In relation to land at 89 Ross Watt Road, Gisborne, Development Plan Application DP/2021/1 (VCAT Ref No DP/2021/1) and Subdivision Permit Application PLN/2021/616 (VCAT Ref No P511/2022)

In relation to land at 89 Ross Watt Road, Gisborne, Development Plan Application DP/2021/1 (VCAT Ref No DP/2021/1) and Subdivision Permit Application PLN/2021/616 (VCAT Ref No P511/2022)

**Comments on Development Plan
89 Ross Watt Road, Gisborne**

Figure 2: Gisborne Futures Draft Structure Plan - incorporating the Western Link

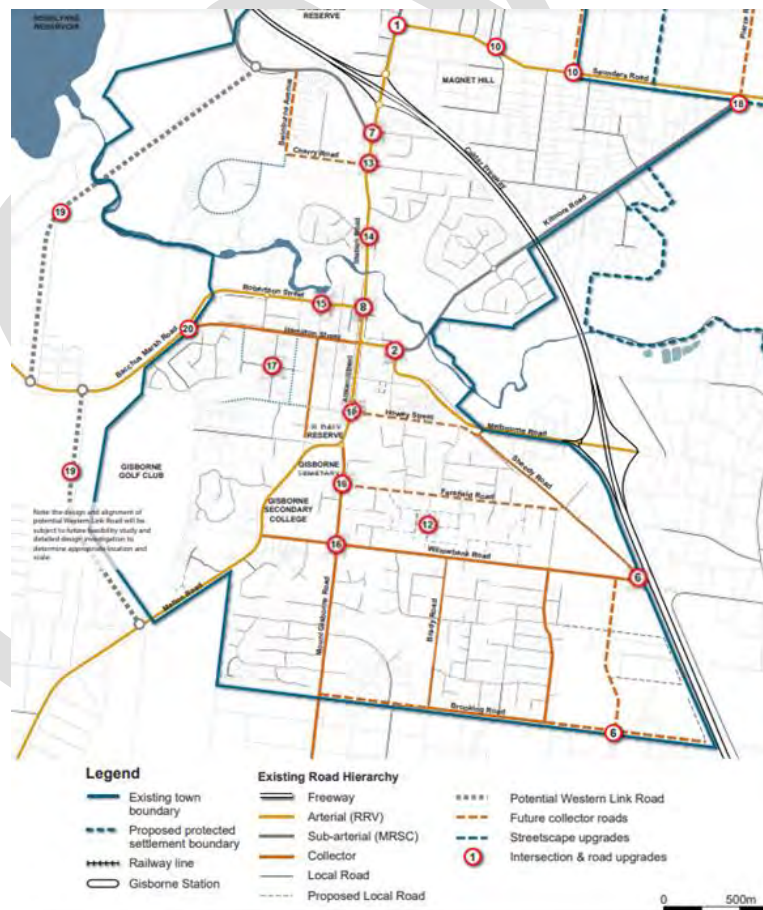
- A more comprehensive suite of traffic management options and commitments be considered, including but not limited to:
 - The role of a completed “Western Link” (as proposed in the Gisborne Futures Draft Structure Plan July 2020, Page 45, “Intersection & Road upgrades”. No 19 below)⁵ be considered.

- Redirection of traffic via the northern section of Ross Watt Road with the inclusion of a north-bound freeway on-ramp – to relieve pressure on the Cherry Lane/Station Road and Ross Watt Road/Station Road intersections;

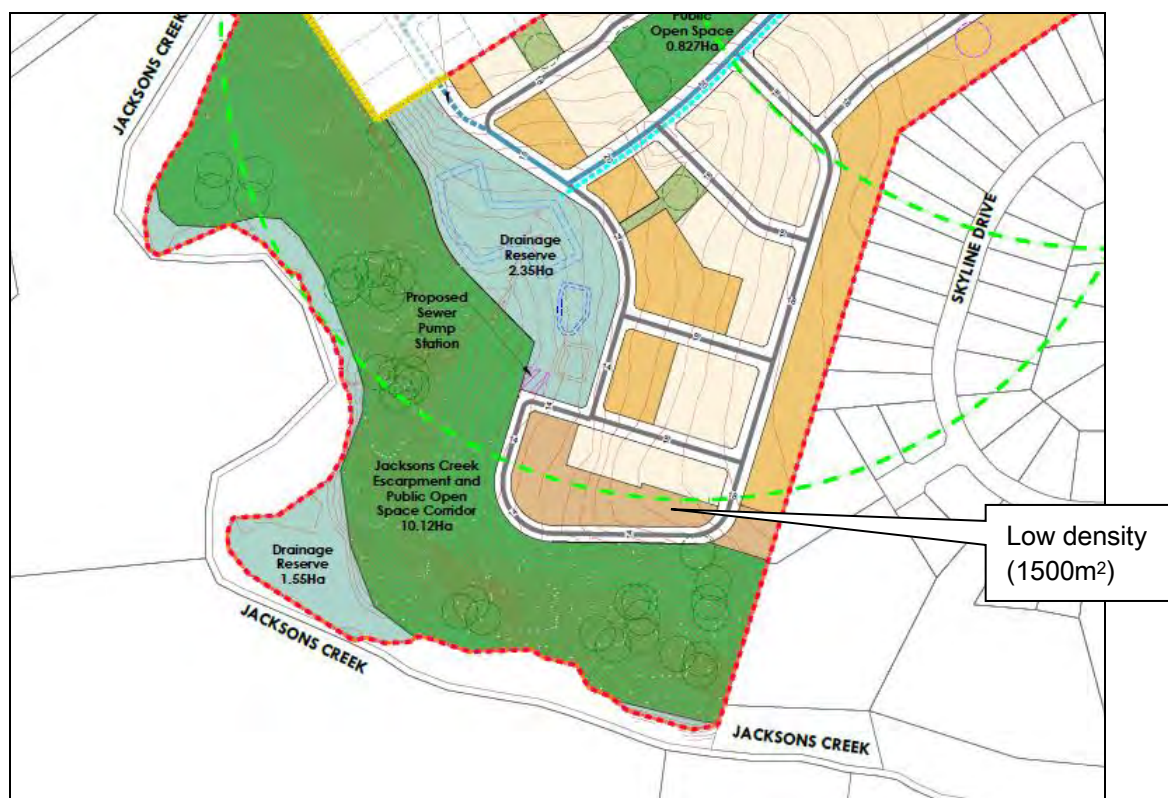
18. The Landscape Concept Plan shown on page 31 of the report by Collie Town Planners Pty Ltd ("the Collie Report") is not included as a document in the Development Plan.

19. Landscaping of the Jacksons Creek Escarpment is stated '*to be detailed in the planning permit stage*' (refer: page 31 of the Collie Report).
20. It is submitted that this is not acceptable when a development plan is required to be consistent with the provisions of Clause 21.13-1 and there are objectives and key principles with respect to view lines, and for limiting the '*visual intrusion of development*' around the Jacksons Creek escarpment; considering suitable landscaping and screening; and improving the open space corridor along Jacksons Creek.

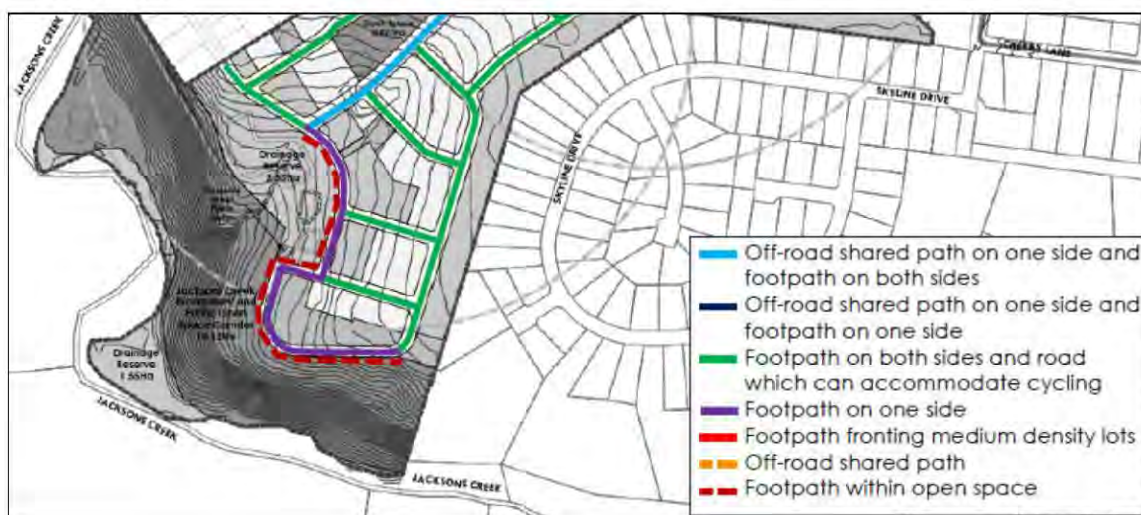
31. This shows a *"Footpath within open space"* south of the southern roadway (see above extract of Figure 8). It is submitted that the Development Plan should include a fence on the southern side of this red hatched footpath.
32. This would not only restrict dogs from accessing Jacksons Creek and entering [REDACTED]'s grazing land, it would also restrict people from creating their own pathways down the escarpment to Jacksons Creek and adversely impacting on the riparian area of the creek and its flora.

Figure 19 Indicative Subdivision Layout Plan

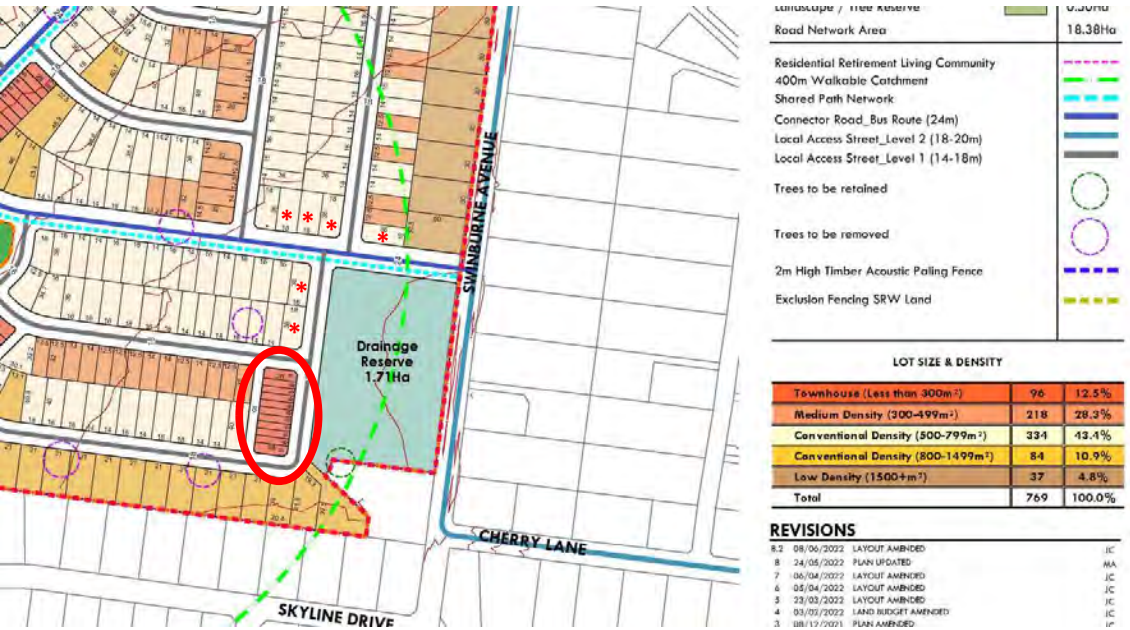
Furthermore, I refer to Figure 19 Indicative Subdivision Layout Plan (Pg. 33 of "Development-Plan-89-Ross-Watt-Road-Gisborne-July-2022.pdf"):

Low density lots (1,500 square metres or greater) located along the various boundaries to respond to the existing low density residential subdivision patterns and adjoining Rural Conservation Zone areas at these interfaces".

The current plan does not fully meet this expectation.

Figure 9-6 2046 Western Link Road and Reference Network, Worst V/C ratios

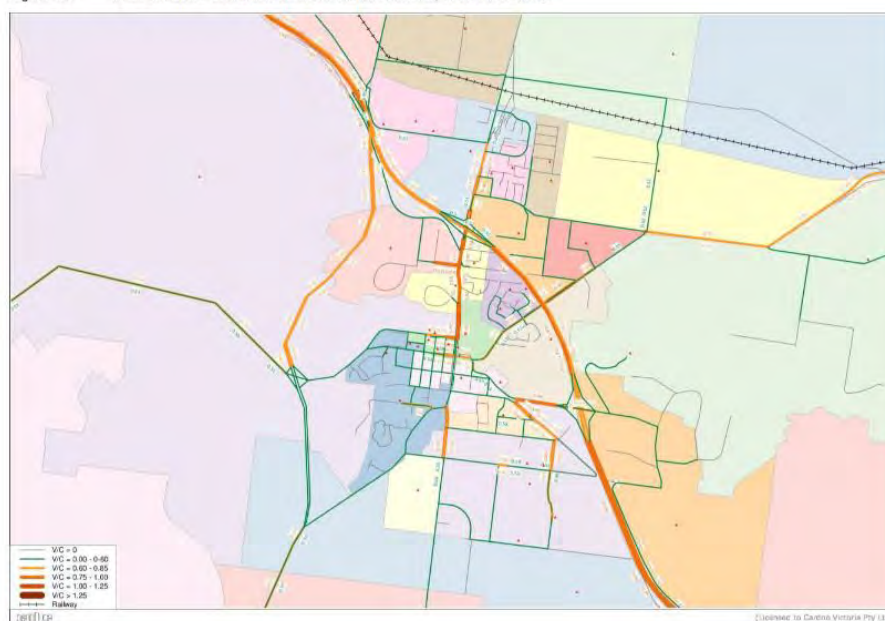
The 89 Ross Watt Road Development Plan would cut-off access for any alignment of a western link road. By way of illustration, the Figure 9-6 of the Gisborne Futures Traffic and Transport Recommendations Report - Appendices (See below) clearly shows the blocking of access for this strategically important link road in the area of the 89 Ross Watt Road Development Plan. (I leave it to the reader to identify significant features in the Figure 9-6.) The Development Plan essentially provides a wall of sub-division from the established residential areas of Gisborne to the RossLynne Reservoir (not shown).

It should be noted that both the Cardno Gisborne Strategic Traffic Model Report and the 89-Ross-Watt-Road-Gisborne-Development-Plan-Transport-Impact-Assessment produced by onemilegrid (A contemporary name with no capital for the pronoun. Company self-described as “A boutique traffic and transport engineering and waste management consultancy firm.”) for the 89 Ross Watt Road Development Plan are statistic rich documents. However, this can only mask the simple concept of effectively processing the increasing number of vehicles both around (bypassing) and into Gisborne. The comparison of the Cardio and 89-Ross-Watt-Road-Gisborne-Development-Plan-Transport-Impact-Assessment may only produce a confusing picture of projected traffic and mask the true situation of increasing traffic congestion through the town.
